802.3df D3.0

Comment Resolution

P802.3df editorial team

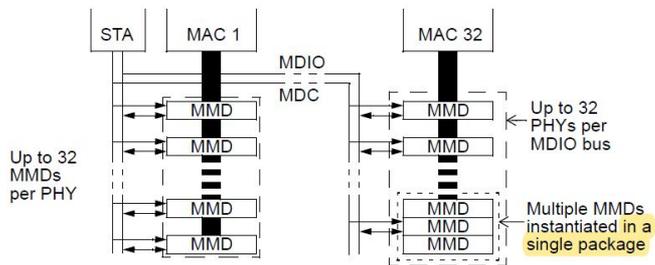
Cl 169 SC 169.4 P182 L28 # I-101
Dawe, Piers J G NVIDIA
Comment Type TR Comment Status D delay wording

It is not clear here whether e.g. a pair of IOs forming an AUI is one PMA sublayer or two. 173.5.4 says "up to four instances of the 800GBASE-R PMA within a Physical Layer", but the relation between instance and sublayer is not given there. 120.5.4, Delay constraints, says "...up to four PMA stages in a PHY (sum of transmit and receive delays at one end of the link) but it's still ambiguous. In 173.5.4, Delay constraints, "...up to four instances of the 800GBASE-R PMA", and the numbers for the PMA in Table 173-1 (not this table 169-4) apply to an instance not a sublayer.

Consolidate the terminology (don't use "sublayer" and instance" for the same thing), and explicitly state somewhere whether a pair of IOs forming an AUI is one PMA sublayer or two. Add cross-references as appropriate, e.g. from the AUI annexes.

Write something like "Each instance of a PMA" in the Notes column. Change the heading of the left column to "Sublayer or instance" if appropriate.

Change "Table 169-4 contains the values of maximum sublayer delay"

To "Table 169-4 contains the values of maximum delay for each instance of a sublayer" Implement with editorial license.

173.5.3.1 Skew generation toward SP1

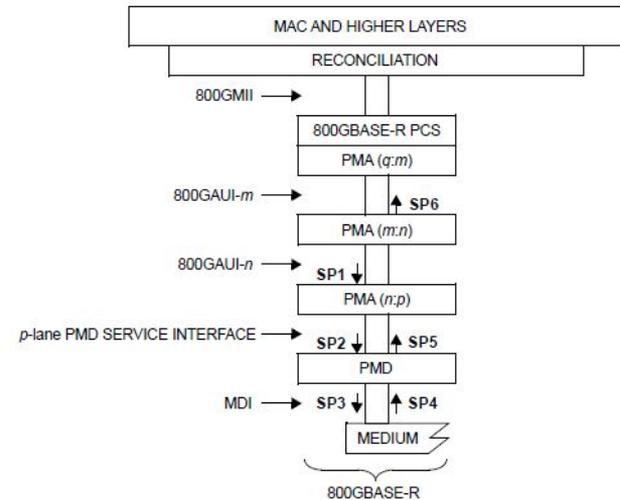
Cl 173 SC 173.5.3.1 P238 L39 # I-69

"shall produce" here, "shall generate" in 173.5.3.3, "shall deliver" in 173.5.3.5... the title of all three has "skew generation".

In fact, the skew numbers stated are cumulative.

Since the skew at any point is not necessarily generated at that point, the proper requirement seems to be "shall have".

Cl 173 SC 173.5.3.3 P239 L53 # I-128

In these subclauses, skew is generated, produced or delivered. It is not clear what these terms mean. I believe that all Skew limits are cumulative (unlike for delay) which has a bearing on what the terms mean.

Change 173.5.3.1 as follows:

In an implementation with one or more physically instantiated 800GAUI-8 interfaces, [at the output of](#) the PMA that sends data in the transmit direction toward the 800GAUI-8 that is closest to the PMD (SP1 in Figure 169–4 and Figure 169–5) [there](#) shall ~~produce be~~ no more than 16 ns of Skew between PCSLs ~~toward the 800GAUI-8~~ and no more than 200 ps of Skew Variation [between output lanes toward the 800GAUI-8.](#)

Figure 173-4—8:32 PMA functional block diagram

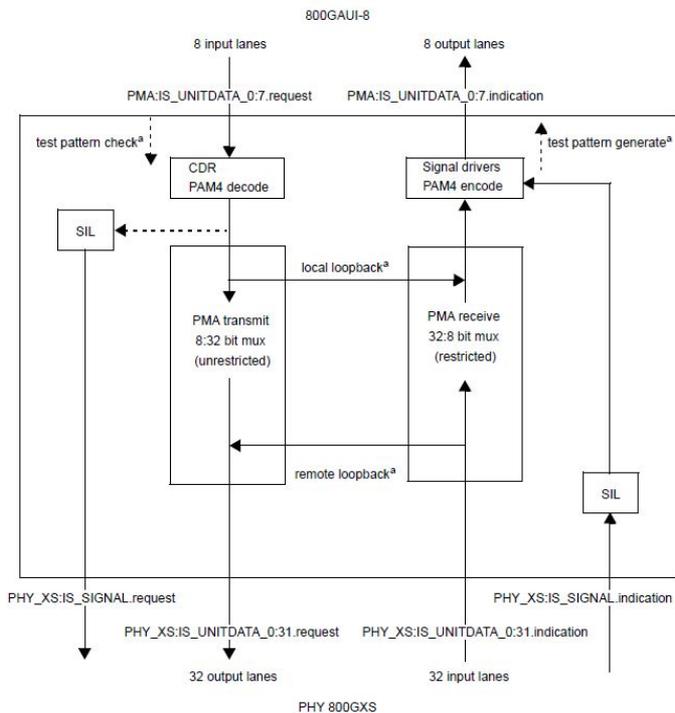
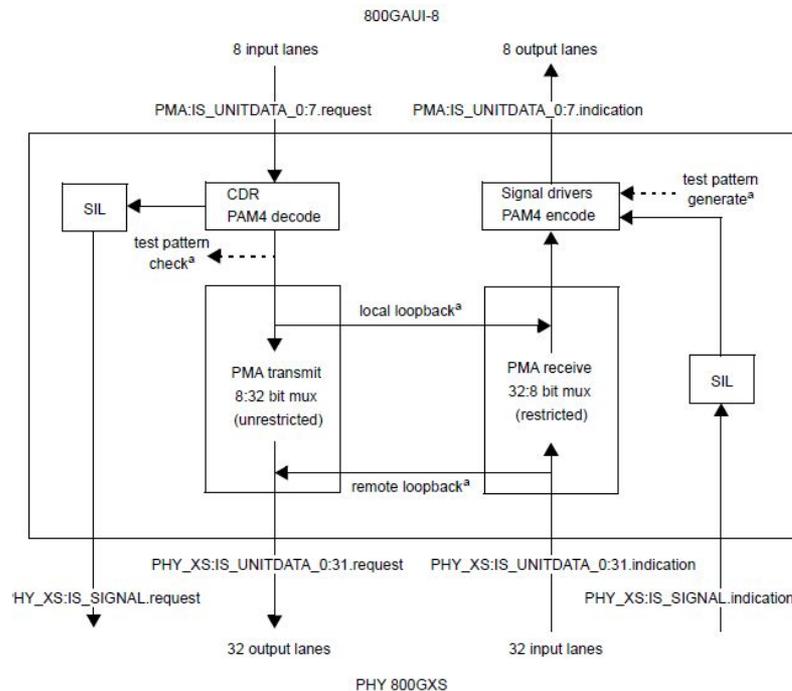
Cl	SC	P234	L35	#
173	173.4.1			I-66
Ran, Adee		Cisco Systems, Inc.		
Comment Type	T	Comment Status	D	test patterns
The dashed-line arrows in Figure 173-3 are not connected to the right places.				
"Test pattern generate" creates bits that are encoded as PAM4 symbols and then driven by the same signal drivers. It should go into the "PAM4 encode/Signal drivers" box.				
"Test pattern check" operates on a bit stream, so should take the output of "PAM4 encode/CDR".				
The arrow leading to "SIL" denotes information from the CDR. It should be taken from the PAM4 decode/CDR box.				
Similarly in Figure 173-4 and Figure 173-5.				
<i>SuggestedRemedy</i>				
Modified figures will be supplied				
Proposed Response		Response Status	W	
PROPOSED ACCEPT IN PRINCIPLE.				
Some updates to the diagram are warranted.				
Slides will be provided to address this.

Cl	SC	P234	L35	#
173	173.4.1			I-141
Slavick, Jeff		Broadcom Inc		
Comment Type	T	Comment Status	D	test patterns
The dotted arrows in Figure 173-3, Figure 173-4 and Figure 173-5 aren't accurately placed.				
<i>SuggestedRemedy</i>				
In all 3 figures				
Shift the dotted arrow(s) going from test pattern generate to have it go into the PAM4 encode and signal drivers box				
Shift the dotted arrow(s) going into test pattern check to come from the PAM4 decode and CDR box				
Shift the dotted arrow(s) going to the SIL to come from the PAM4 decode and CDR box				
Proposed Response		Response Status	W	
PROPOSED ACCEPT IN PRINCIPLE.				
Resolve using the response to comment #I-66.

Proposed update to Figure 173-4
